MEMORANDUM

SUBJECT: 2 Morgan Drive, LLC  
2 Morgan Drive, SBL 80.55-1-2.1/4

FROM: Jan K. Johannessen, AICP   
Village Planner

DATE: 02/15/2019 | SCALE: 1" = 30' | DWG. NO. 2018-39006 | SHEET 2 OF 8

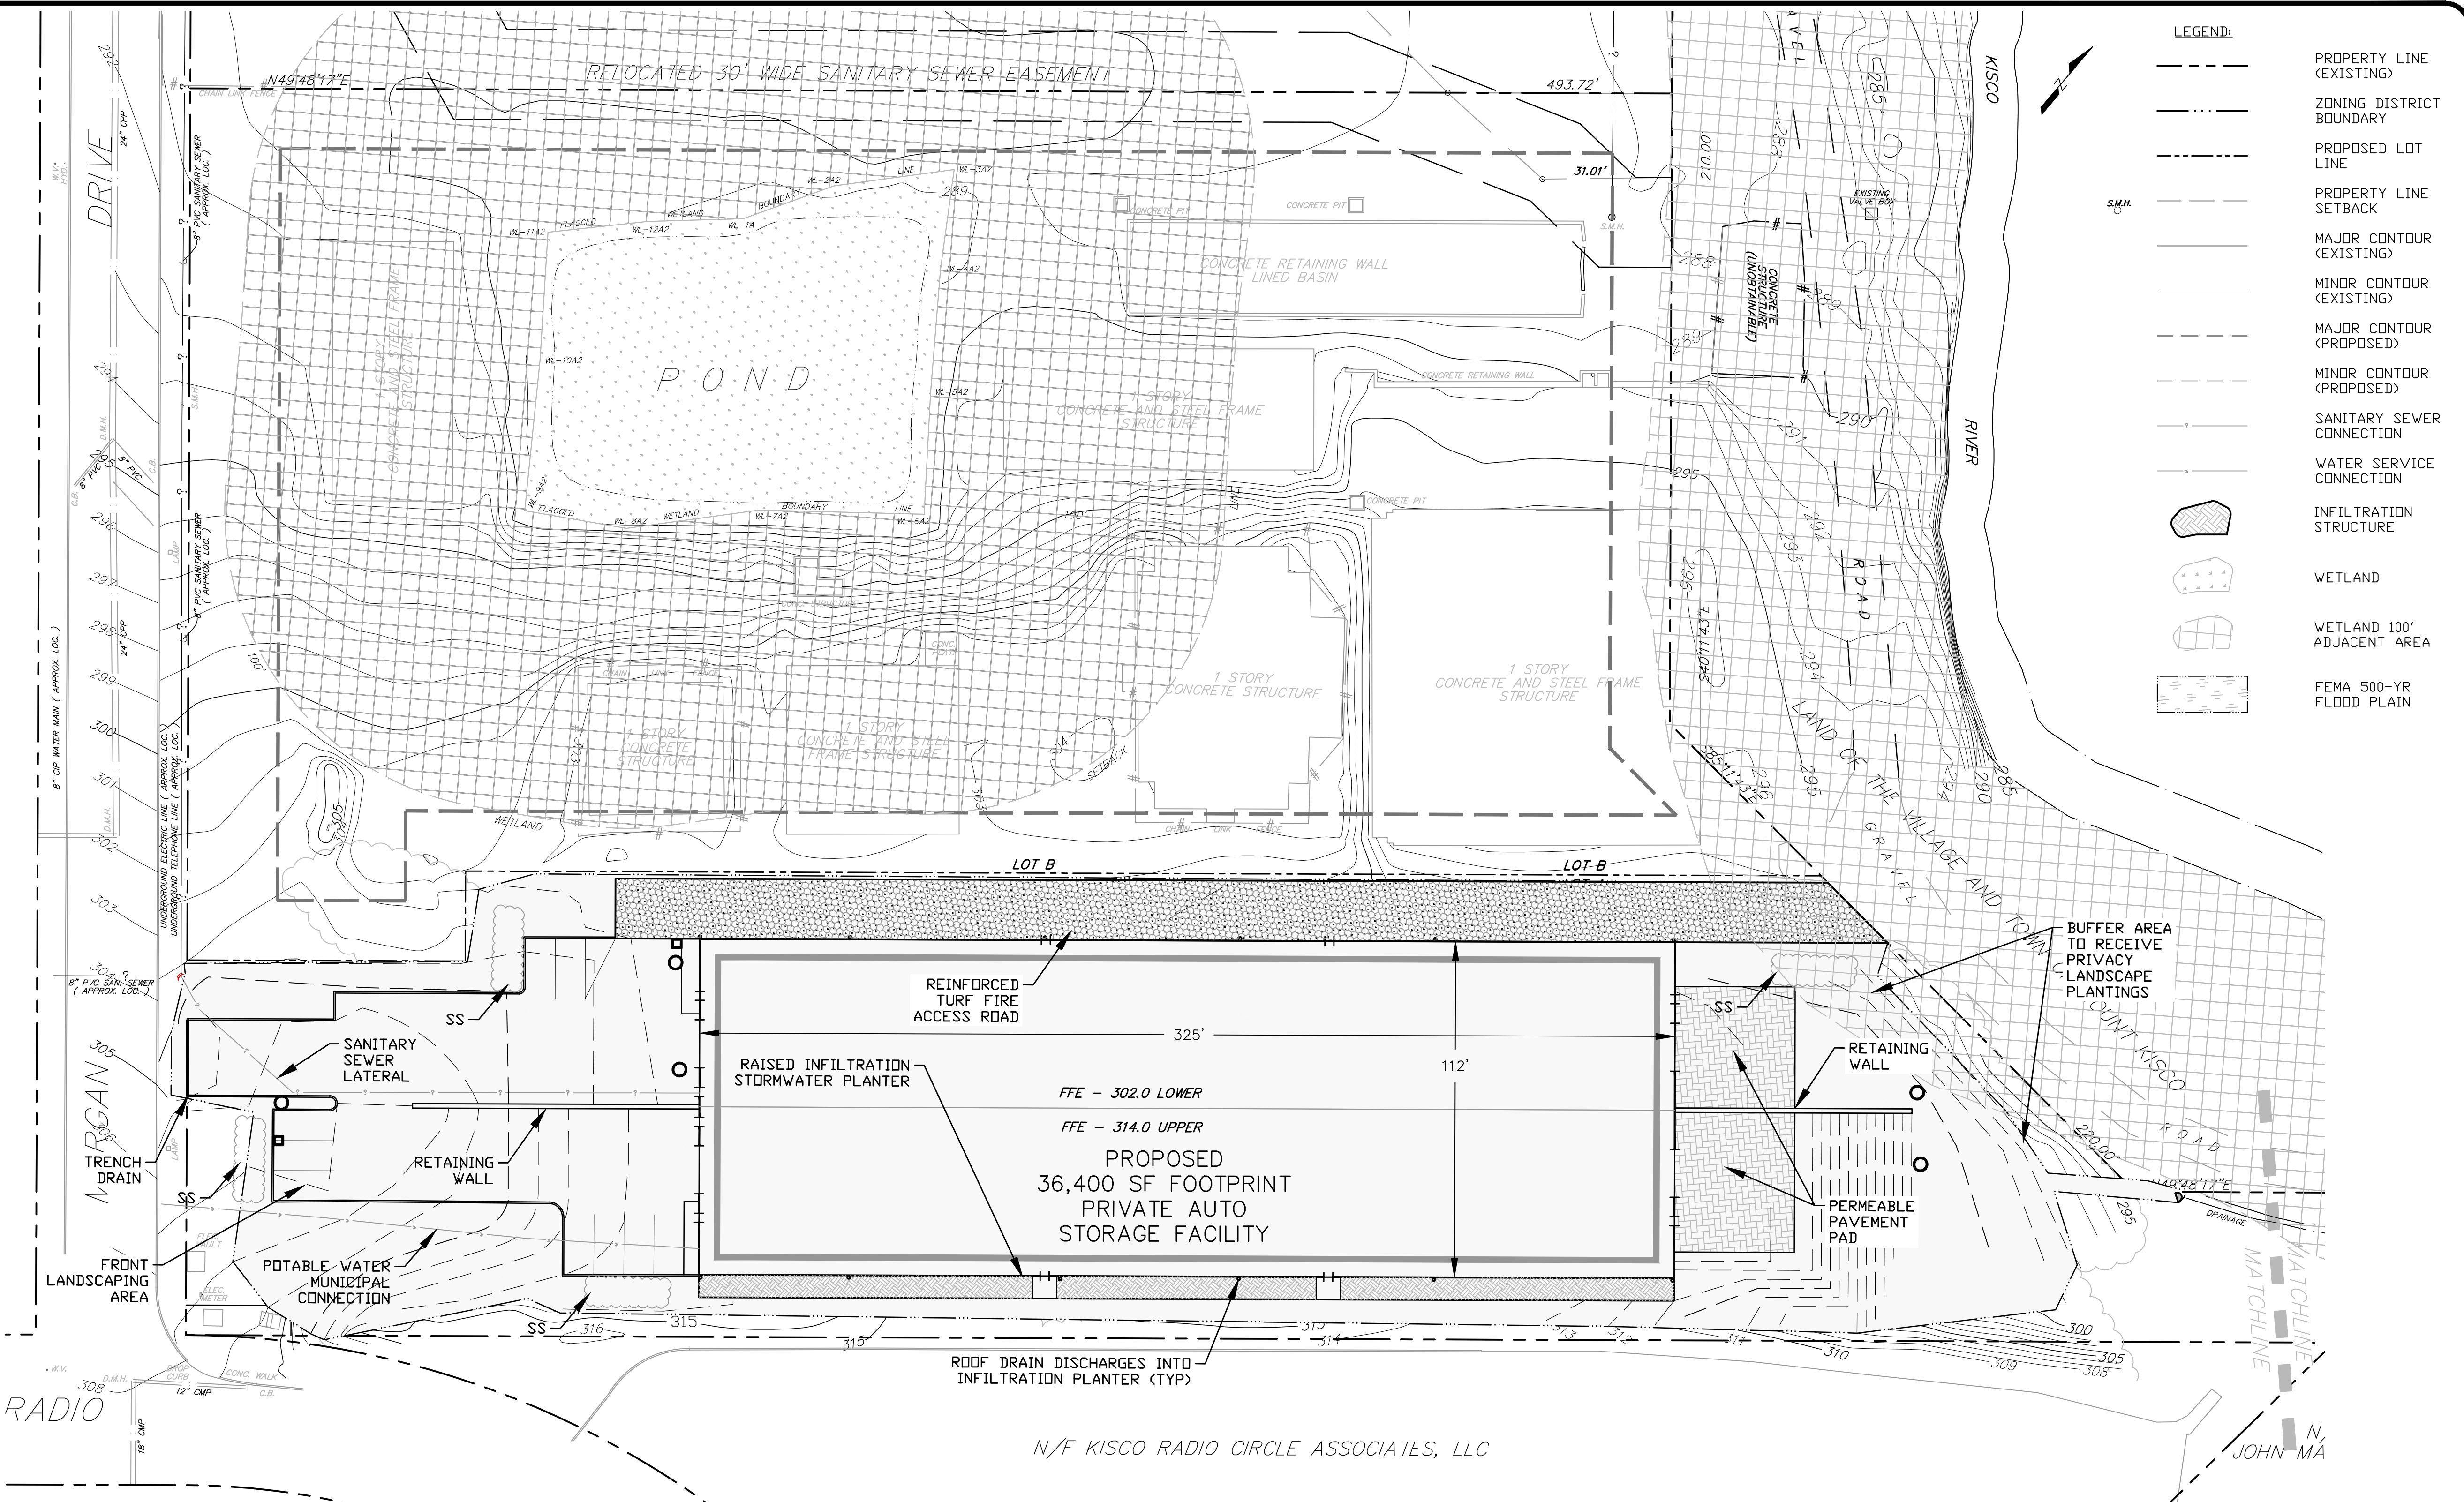
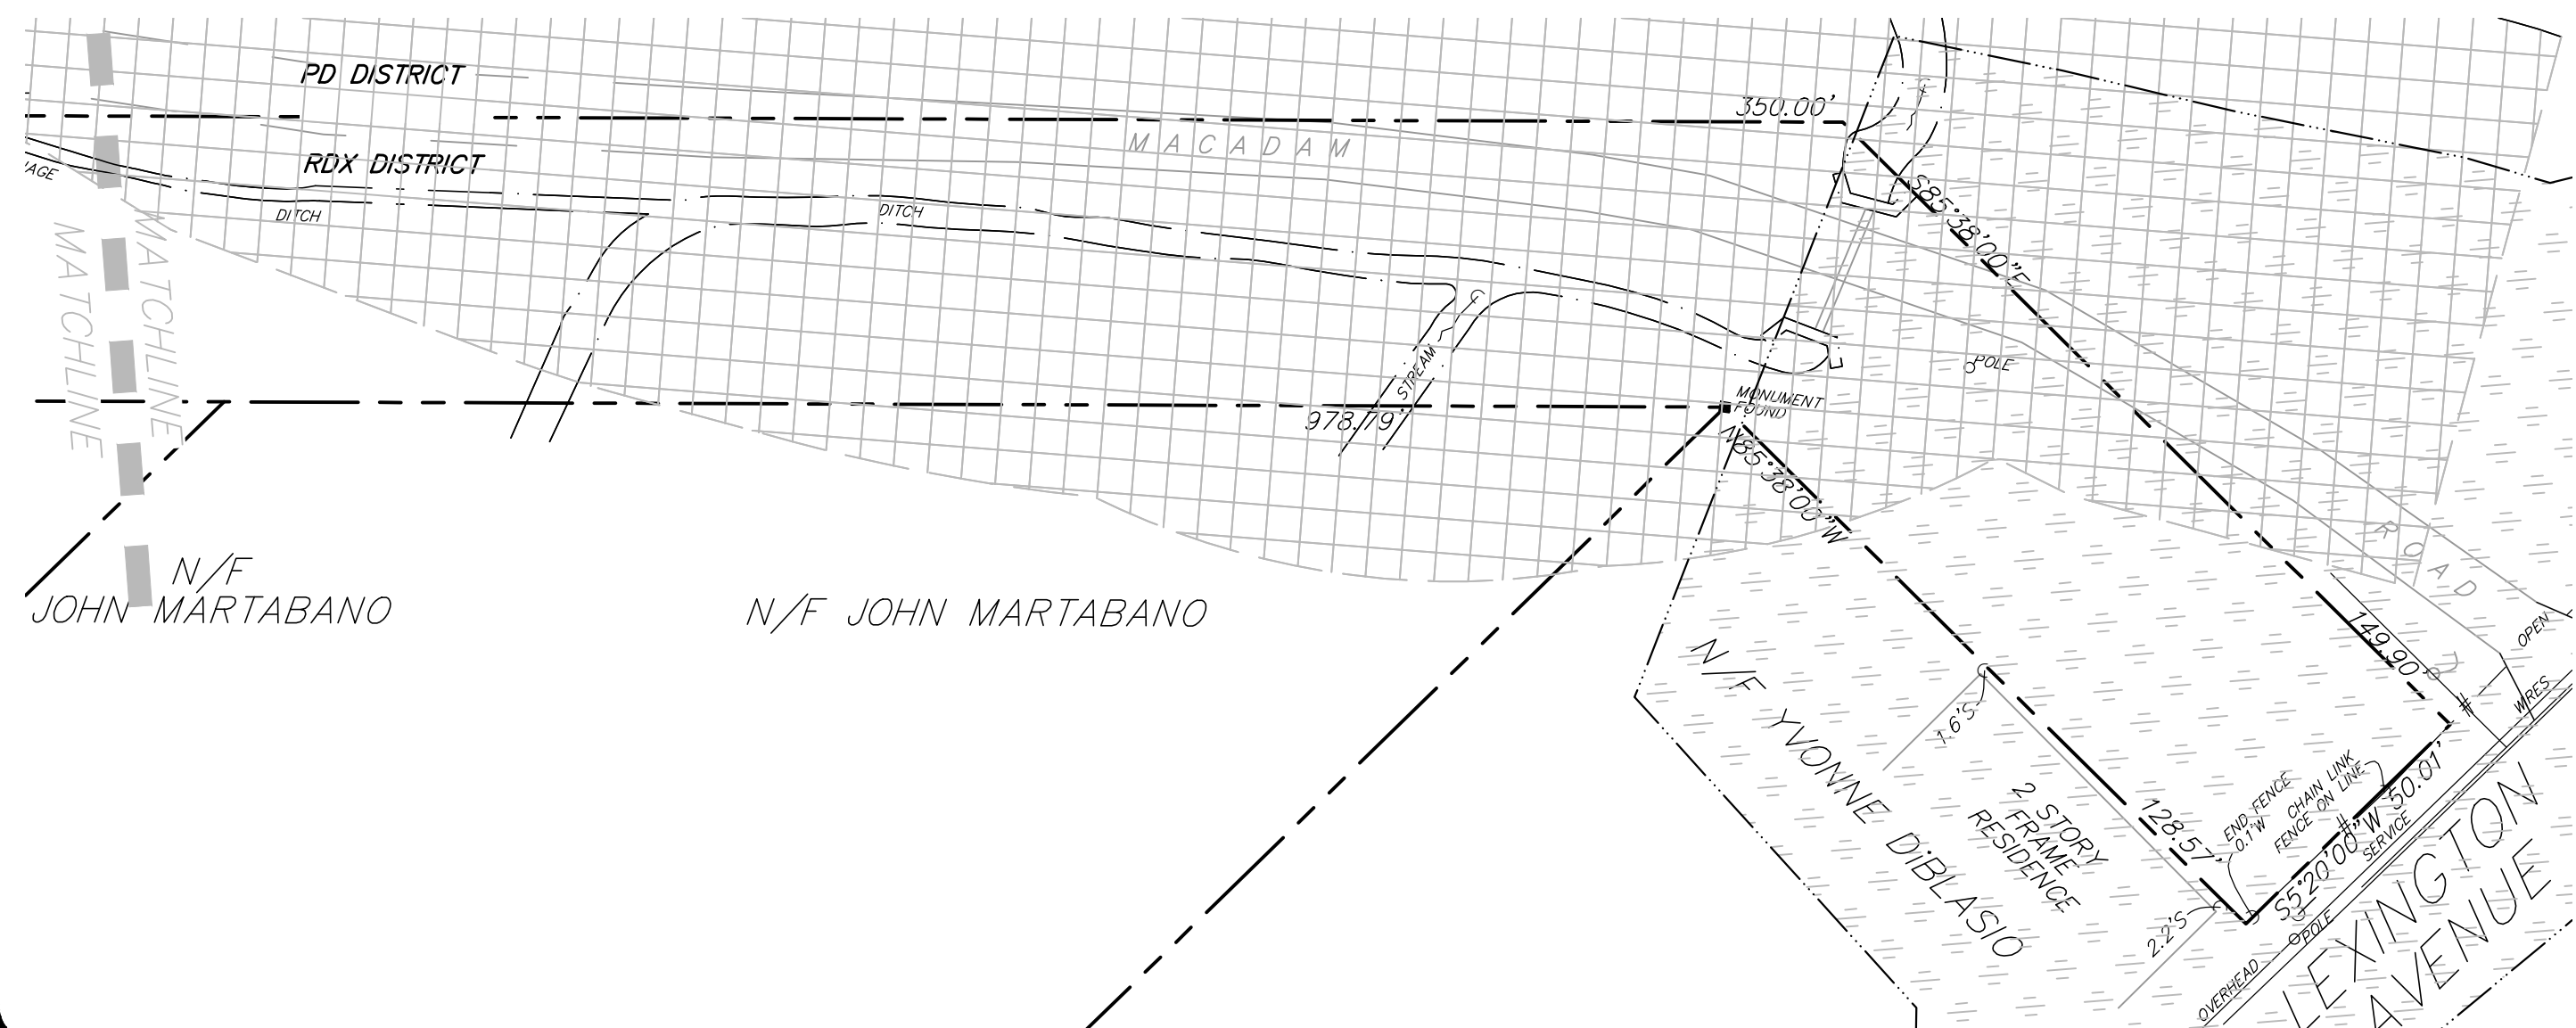
9. While it is helpful to visualize the proposed development of Lot A in relation to Lot B, as depicted on Sheet 2, separate site plans, grading plans, drainage and utility plans, etc. shall be provided which illustrate Lot A only. It would be helpful if the grading plan for Lot A was revised to better decipher between existing and proposed contour lines; additional contour labeling and proposed spot elevations should also be incorporated. Drawings have been revised. A final Drawing set can not be completed until the NYCDEP approved the Stormwater Plan.

DATE: 03/02/2020 SCALE: 1" = 20' DWG. NO. 2018-39010 SHEET 5 OF 8

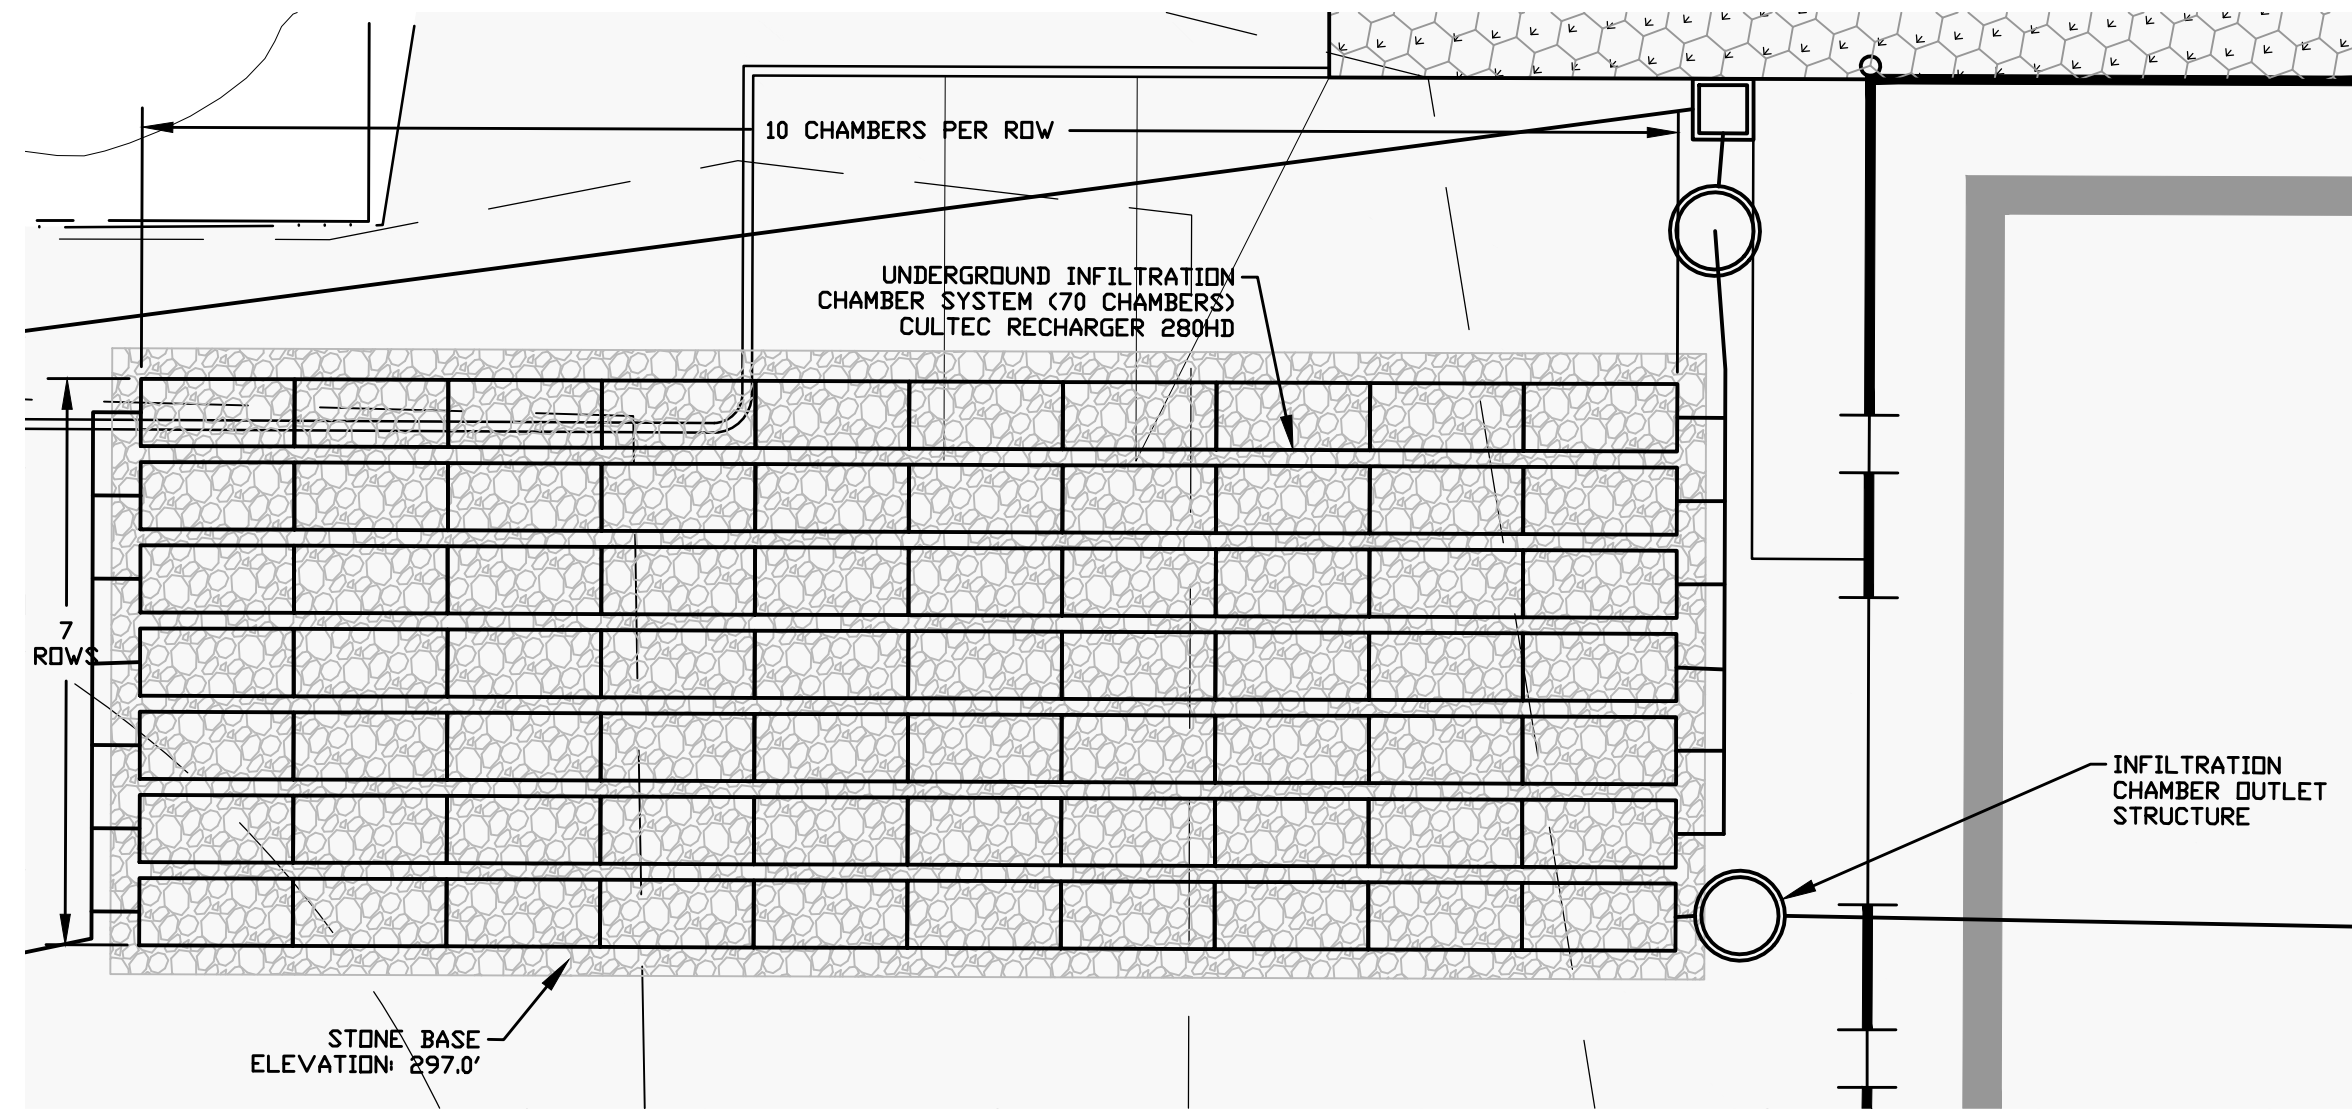
18. The applicant has indicated that no exterior dumpster or refuse container is proposed; a note to this effect shall appear on the site plan.
19. The area of land disturbance (s.f.) shall be calculated and identified on Sheet 5.
